Project Location:	601 MacArthur Boulevard (vacant parcel is located at the corner of Wesley Ave
Assessor's Parcel No:	023 042700200, 023 042700100, 023 042700803
Development Proposal:	Referral for design modifications to a previously approved project that was recommended to the Planning Commission on December 20, 2017 for the construction of a four-story 25-unit residential condominium building with underground parking.
Project Applicant / Phone Number:	James Branch / The Lake House Development (415) 678-0427
Property Owner:	Yila Properties
Case File Number:	PLN17281
Planning Permits Required for Approval by the City Council:	1) Rezoning of RM-3 Zone (Mixed Housing Type Residential) to RU-2 Zone (Urban Residential); 2) Regular Design Review for construction of a residential building; and 3) Tentative Parcel Map Subdivision for condominiums and merging lots.
General Plan:	Mixed Housing Type
Zoning District:	RM-3 Mixed Housing Type Residential (existing) RU-2 Urban Residential (proposed)

CITY OF OAKLAND PLANNING COMMISSION

Case File: PLN17281
Applicant: James Branch
Address: 601 MacArthur Blvd (vacant parcel located at the SE corner of Wesley Ave)
Zone: RM-3 (existing); RU-2 (propo

1 NORTH ELEVATION @ MACARTHUR BLVD.
SCALE 1/8" = 1'-0"

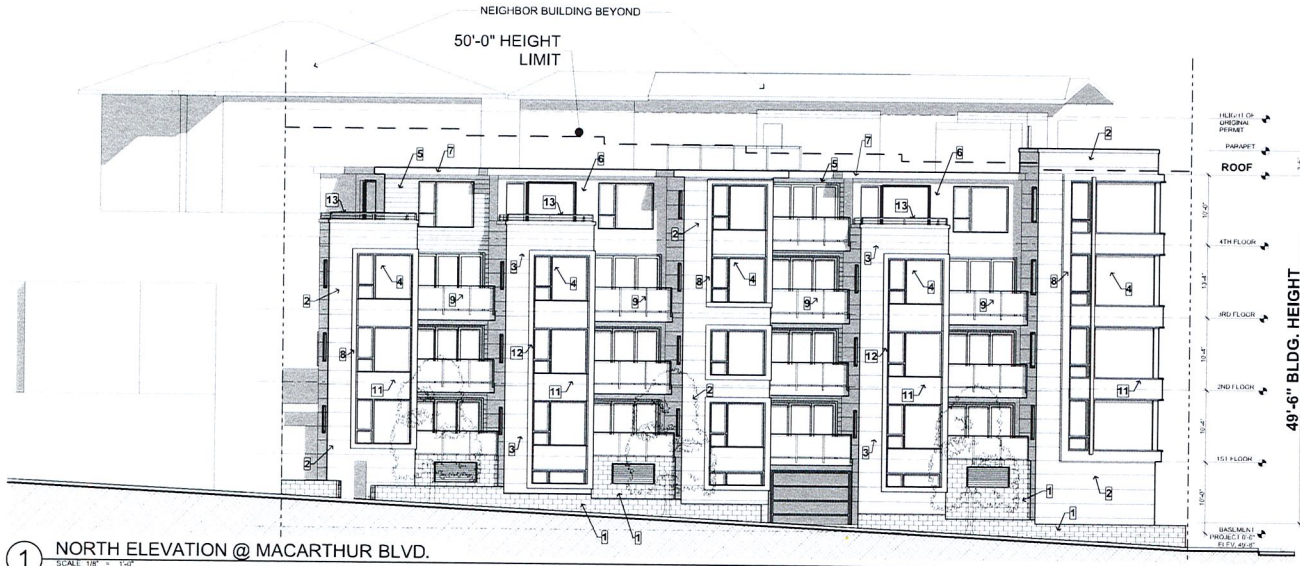
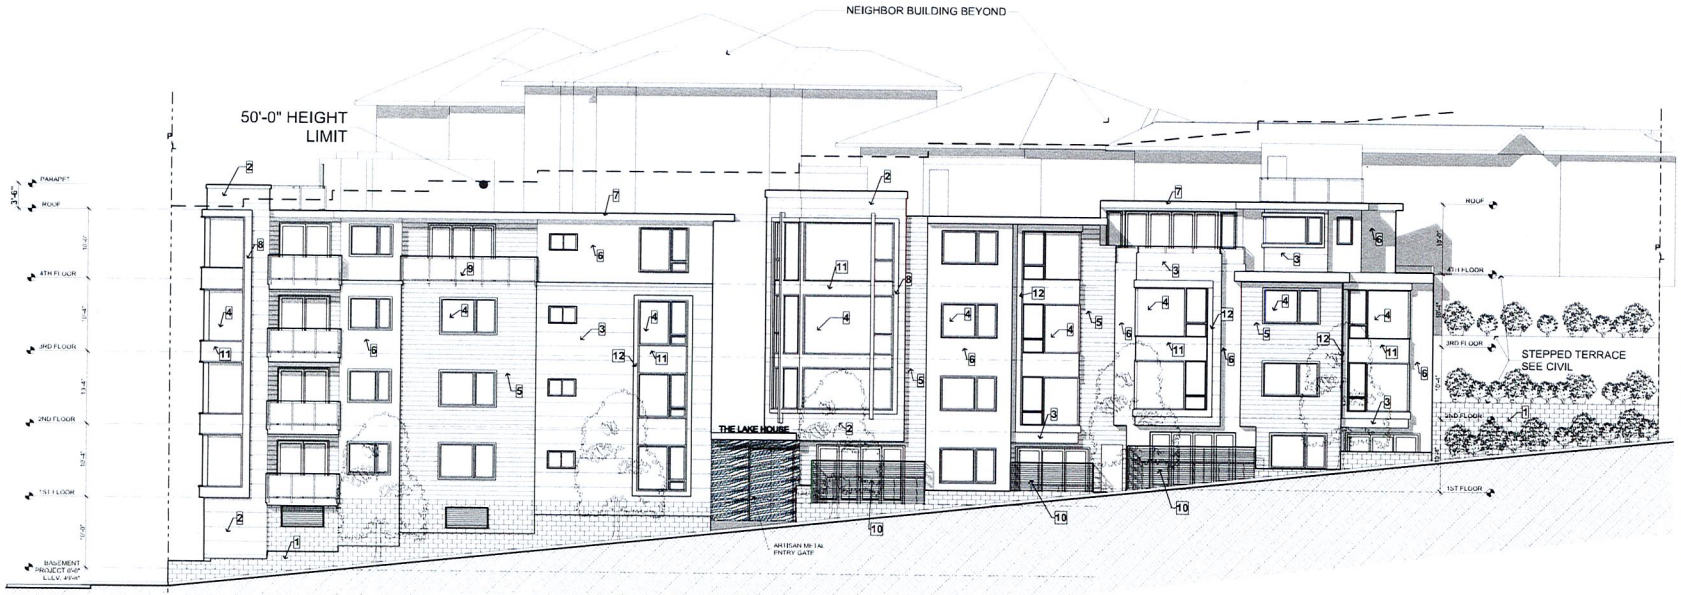
- a) Provide stronger front vertical facades
The modified plans show one of the bays in the center of the façade along MacArthur Boulevard was raised vertically to have a balance and stronger façade composition;

- b) Break up the linear footprint of the front balconies
The modified plan shows the reduction of the 4th floor balconies. The linear configuration of the balconies were reduced by more than fifty-percent, thus avoiding a repetitive pattern on the building façade. To make up for the loss of the balcony area, the modified plan also shows new additional balconies, located between the 1st and 4th floors along Wesley Avenue.

- c) Replace the orange color on the building
The applicant submitted a modified color and material board sample showing the replacement of the orange color palette with a Mahogany red color to provide a coherent composition and style. The modified plans also show two perspectives views of the building and new proposed colors.
